Subject: MHI's Second Responses to US-APWR DCD RAI No. 752-5614 Revision 0 (SRP 19)

MHI's Second Responses to Request for Additional Information
No. 752-5614 Revision 0

US-APWR Design Certification

RAI NO.: NO. 752-5614 REVISION 0
SRP SECTION: 19 – Probabilistic Risk Assessment and Severe Accident Evaluation
APPLICATION SECTION: SRP Chapter 19
DATE OF RAI ISSUE: 5/3/2011

Figure A-1 Maximum plastic strain of RCS pipes

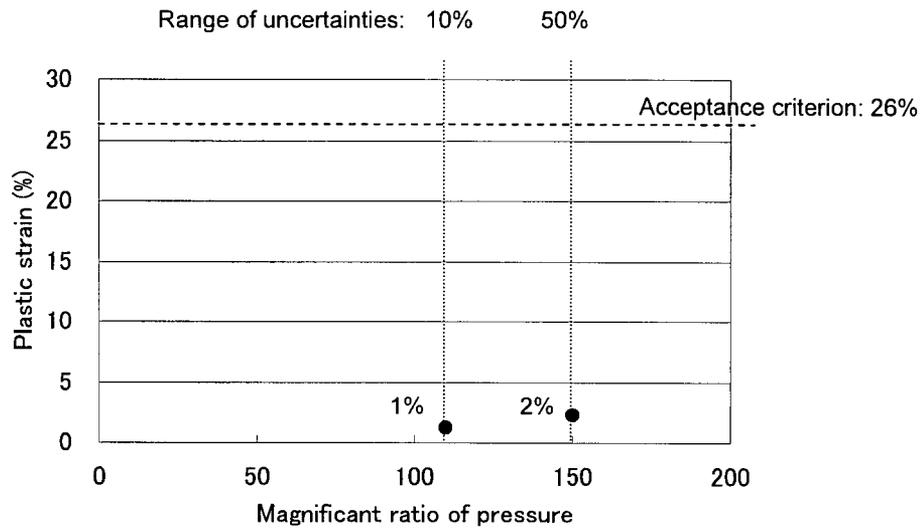
The RAI response also stated that for the U.S. APWR design certification analysis, the evaluated pressure is increased by 10% in order to take into account the modeling uncertainties. Considering the above noted differences between the results of the original and the MHI-version of the TEXAS-V computer code calculations, the use of pressure/pressure impulse history predicted by the original TEXAS-V code in the U.S. APWR cavity structural analysis may lead to significantly lower margin between the calculated plastic strain and the maximum allowable strain. Therefore, please investigate the implications of using a larger range of uncertainties in the calculated peak pressure/pressure impulse (i.e., as much as 50% instead of the MHI-assumed 10%) associated with the steam explosions-induced dynamic loads on the cavity structural failure probability.

The relationship between magnificient ratio of pressure and maximum plastic strain are shown in Figure A-1 (reactor coolant system pipe), Figure A-2 (reactor cavity wall model (a)) and Figure A-3 (reactor cavity wall model (b)). By increasing magnificient ratio of pressure from 110% to 150%, about twice maximum plastic strain occurred. The RCS pipe structures have sufficient capability to withstand the challenge by postulated ex-vessel steam explosion pressure load multiplied by 150%. However for the reactor cavity wall, the analysis showed that there is a possibility that the structural integrity cannot be maintained depending on the analysis model and partial collapse may be anticipated; although, the area of collapse is very limited. The reactor cavity wall model (a), which is originally reported in the PRA Report Ch. 15, shows that the plastic stain from 150% load exceeds the acceptance criterion. On the other hand, the reactor cavity wall model (b), which is another model developed during the study but not reported in the PRA Report Ch. 15, shows that the plastic strain is evaluated below the acceptance criterion. In the analysis using the model (a), it can be considered that some triangular elements smaller than other nearby elements may reduce the accuracy of continuity of steel plate deformation, accordingly unrealistically large plastic strain seems to occur very locally. On the other hand, regarding the model (b), because the mesh partitions are uniformly arranged as quadrangular elements in consideration of the direction of stress, the analysis using the model (b) seems to evaluate actual structural response with higher accurately.
